**HAMBURG TOWNSHIP PLANNING COMMISSION
WEDNESDAY, NOVEMBER 20, 2019 7:00 P.M.
HAMBURG TOWNSHIP HALL BUILDING
10405 MERRILL ROAD, HAMBURG, MICHIGAN**

Agenda Item: 7a MSP 19-001

Project Address and description: 7674 E M-36

Project Description: Two proposed permanent signs, a wall sign and a freestanding sign, located at 7674 E M-36 (Advanced Water). The proposed freestanding monument sign would also require a waiver to size requirements of the code. The proposed freestanding monument sign is 36 square feet where 32 square feet is allowed by the township regulations.

Sign 1: A proposed 6 foot tall, 36 square foot, aluminum cabinet, freestanding monument sign on a 9 square foot base. The proposed lettering on the sign is internally illuminated with push through acrylic letters. Also included in this monument sign is an 18 square foot electronic display panel.

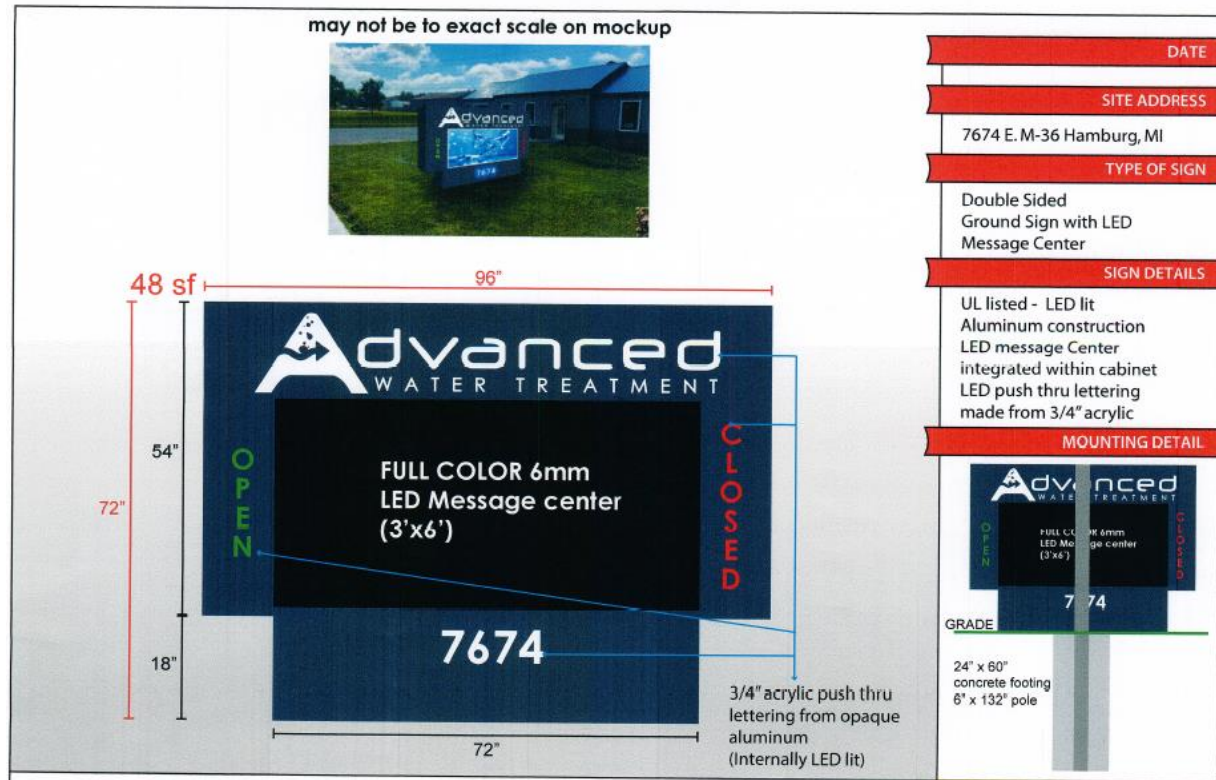
The applicant is requesting a waiver for the sign size. The proposed sign is 36 square feet and the code allows freestanding signs to be

The proposed freestanding sign does not meet the size requirement of 32 square feet for freestanding signs. The applicant has proposed a 36 square foot sign and is requesting a waiver to the sign size.

Staff believe to meet the requirement that the proposed freestanding sign be architecturally harmonious with the character of the building the sign should be reduced in size to 32 square feet, the color of the base should match the color of the bottom of the building and the background color of the sign should match the color of the upper portion of the building. Also the sign should be surrounded by a small landscaped area around the base.

The proposed freestanding sign utilizes an 18 square foot electronic display panel. Although I am not a fan of these types of signs and do not believe that electronic display panels are compatible with the aesthetic character that the Township wished to achieve through the Village Center Master Plan, if there is any location within the Village Center Area or the Village Core District where an electronic display panel sign would be appropriate it would be along M-36 in this location. The location is near the more industrial portion of the development along M-36 and is not near a main entrance to the Old Hamburg Area such as this.

1. The freestanding sign should be reduced in size to 32 square feet.
2. The color of the base should match the color of the bottom of the building and the background color of the sign should match the color of the upper portion of the building.

3. The freestanding sign should be surrounded by a small landscaping area to be submitted by the applicant and reviewed by staff as part of the land use permit.

If the Planning Commission approved the proposed sign application staff suggest that the freestanding sign should be redesigned to utilize individual channel letters that are both internally and halo lit for the Advanced Water Treatment wording at the top of the freestanding sign.

Signs 2: A proposed 12.75 square foot, channel letter, wall sign attached to the wall of the garage structure over the roof of the office/ sale building. The sign is both internally illuminated and halo lit.

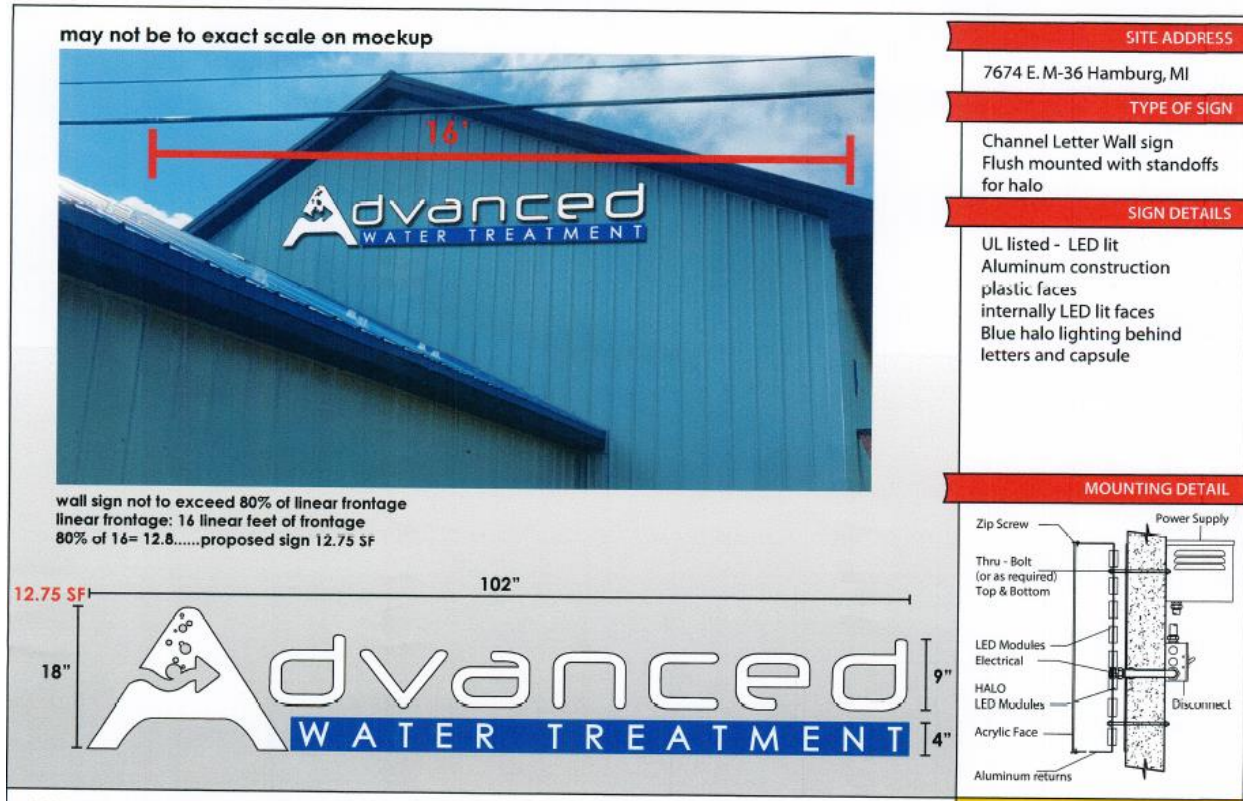
The proposed wall sign is located on the wall of the storage garage structure above the roof of the office and is not located in a sign band area above the store front. Because the word generally is used in this regulations it is not a requirement that the wall sign be located in a sign band above the store front it is a suggestion on building where it would

The proposed wall sign appears to be less than the allowable sign of .75 square foot per linear foot of building frontage. The main building on the site has 32 linear feet of frontage, however the wall of the building that the sign is located on only has 16 linear feet of frontage. If the entire building front was used (32 linear feet) for the building frontage a wall sign of 24 square feet would be allowed if the building front of the portion of the building the sign is located on is used (16 linear feet) as the building front a 12 square foot wall sign would be allowed. The proposed wall sign is 12.75 square feet.

The lettering of the proposed wall signs does not exceed 18 inches in height.

Double Sided
Ground Sign with LED
Message Center

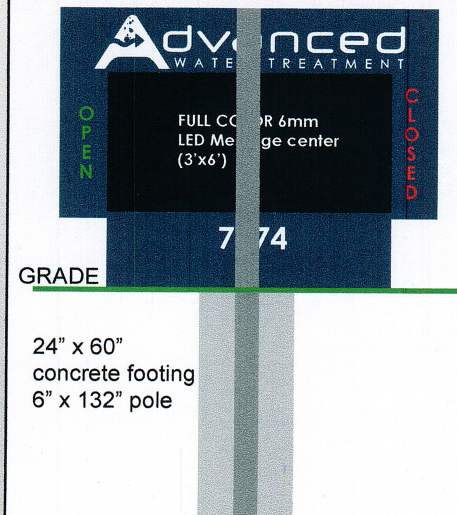
As previously stated in the report to create a sign that is more compatible with the building design staff suggest the following three changes to the sign: 1) to make the sign more in scale with the size of the building the sign should be reduced to 32 square feet which is the size allowed by the township regulations without a waiver from the Planning Commission, 2) the color of the base should match the color of the bottom of the building and the background color of the sign should match the color of the upper portion of the building and 3) the sign should be surrounded by a small landscaping area.

As stated earlier in this report staff believe that in order to provide a more upscale aesthetic for the proposed freestanding sign and to better match the proposed wall sign on the building, and other signs approved in the village center area that have recently been approved along M-36 (CVS and CEI) the lettering of the freestanding sign should be designed as individual channel letters that are both internally and halo lit.

Also to better match the subject structure the colors of the sign should be revised so the base of the sign is the color of the bottom portion of the building and the main upper portion is the color of the upper portion of the building.

Channel Letter Wall sign
Flush mounted with standoffs
for halo

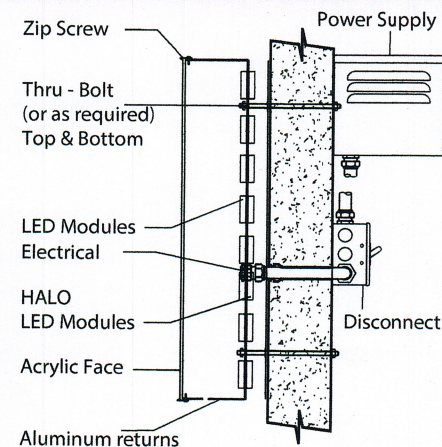
This sign is located on the upper portion of the attached storage garage and is setback from the street and surrounding properties. Because of the location, design and size of the proposed wall sign it appears that the sign will be compatible with the building design, as well as harmonious with other nearby developments.
